Subject: MHI's Amended Response to US-APWR DCD RAI No. 735-5723 Revision 0 (SRP 09.01.03)

Amended Response to Request for Additional Information
No. 735-5723 Revision 0

SRP SECTION: 09.01.03 – Spent Fuel Pool Cooling and Cleanup System

QUESTION NO.: 09.01.03-7

Figure 2.7.6.3-1 Spent Fuel Pit Cooling and Purification System

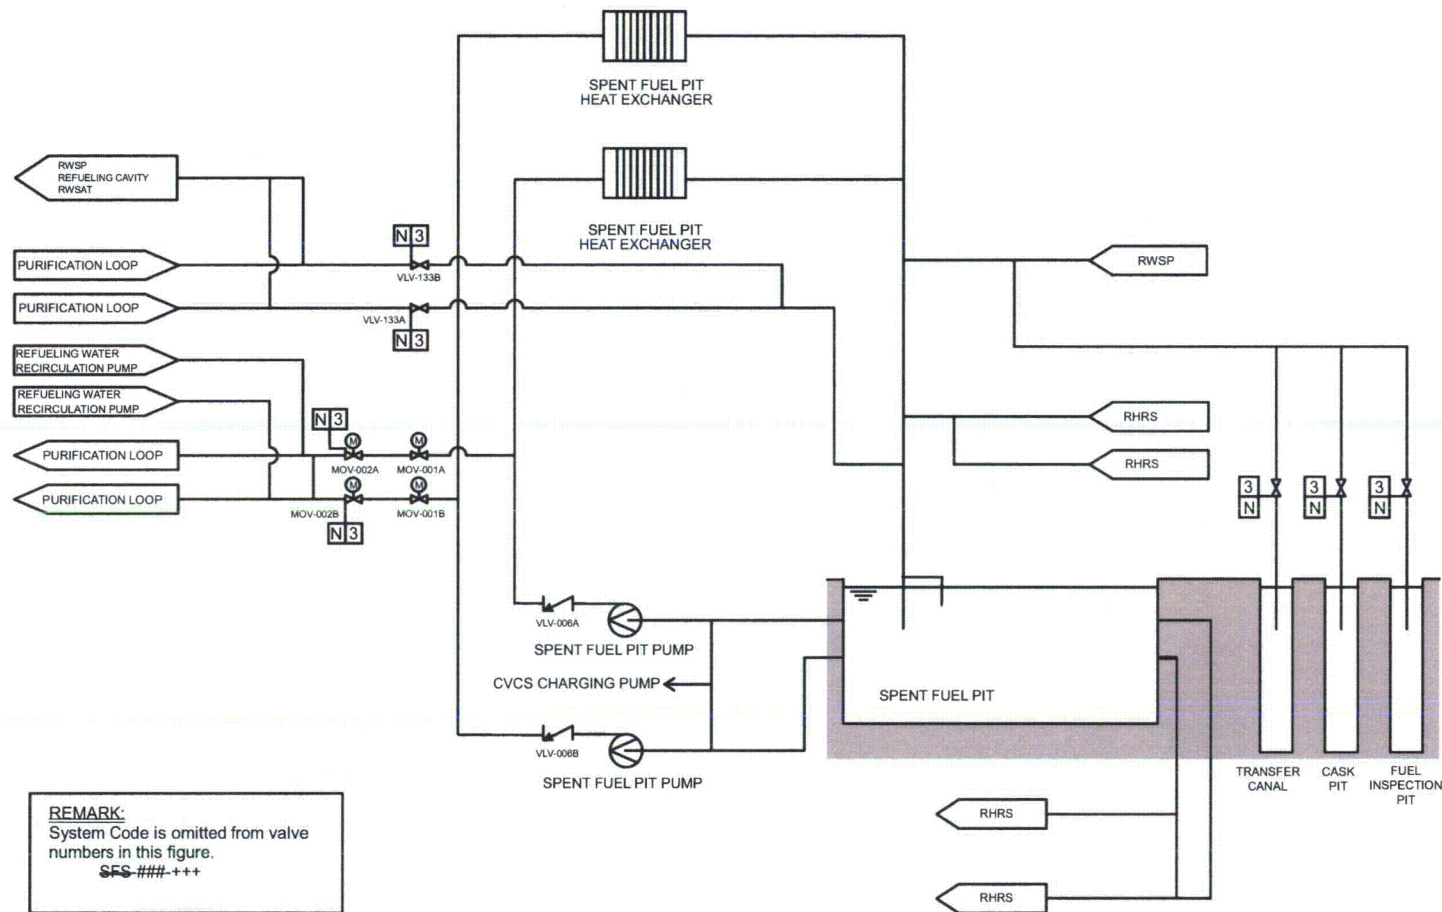
Therefore, the applicant is requested to provide additional information in Tier 2, Section 9.1.3 of the DCD to address how presumed failures of non-safety-related portions of the SFPCS due to a seismic event or an internally generated missile event do not adversely affect the safety-related portion of the SFPCS, pursuant to the requirements of GDC 2 and GDC 4.

- The local manual isolation valve between the safety and non-safety portion (VLV-101A/B) of each train will be changed to double, automatic isolation MOVs which close on a low-low SFP water level signal. The MOVs will be powered by independent electrical divisions. There will be two SFP water level gauges ^(NOTE 1) with independent power supplies. By using independent valve closure signals, at least one isolation valve can be closed, considering the single-failure criterion.

DCD_09.01.
03-7 S01
